Scott Horsley
Water Resources Consultant
39 Chestnut Street • Boston, MA 02108 • 508-364-7818

February 7, 2024

RE: Thorndike Place

Figure 1 – Site Plan Hydrology (Groundwater Levels -Blue, Wetlands Elevations - Green)

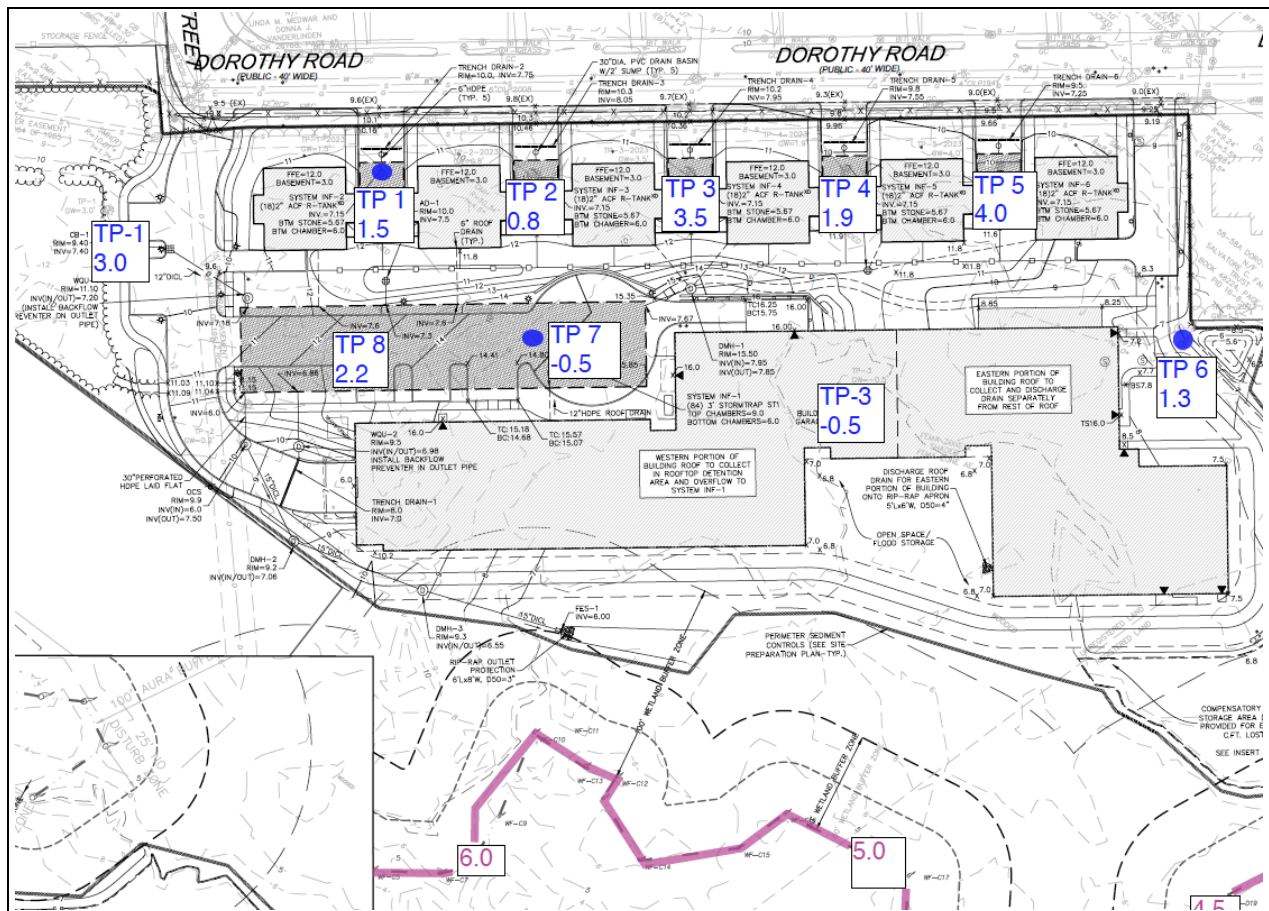
As was stated at the last hearing the Applicant proposes to rely upon mottling (redox) markings at Test Pit 5 which is located approximately 150 feet outside of the proposed infiltration system 1 and to ignore/discount the mottling (redox) features noted at Test Pit 7 (that is located within the footprint of the proposed infiltration system #1) – see figure 1.

The Applicant has not provided clear evidence for ESHGW levels at the proposed infiltration system locations. Additionally, and as stated in my previous comment letter, some of the ESHGW levels that have been provided by the Applicant are inconsistent with wetland elevations and each other.

Recommendation: Require the applicant to install monitoring wells at the infiltration locations and measure groundwater levels throughtout the March, April, and May period. Compare the recorded water levels with USGS index wells.

Figure 2 – Hantush Model Results (Duration 0.46 Days - BSC, Stormwater Report, Revised September 2023)

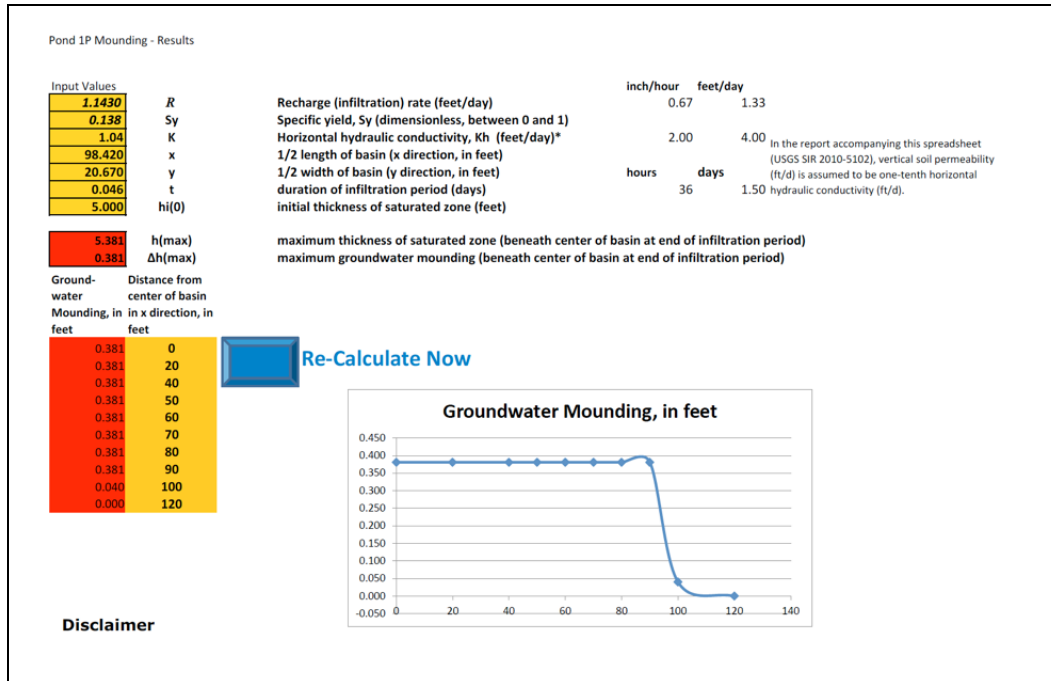
3. The Applicant’s groundwater mounding analysis relies upon a modeled infiltration duration of 0.46 days (1.1 hours) to simulate the impacts of a 24-hour design storm. The Stormwater Report does not provide an explanation for this apparent discrepancy. The MADEP Stormwater Handbook requires that the groundwater mounding analysis be conducted for the 24-hour design storms (10, 25, and 100-year events). These storms by definition have a duration of 24 hours. The submitted groundwater mounding analysis was conductd for a duration of 1.1 hours (see figure 2). This suggests to me that the groundwater modeling therefore significantly underestimates the groundwater mounding associated with the proposed project.

Recommendation: Request the applicant to provide a written explanation of their groundwater modeling and specifically why they selected a 0.46 day (1.1 hour) duration.
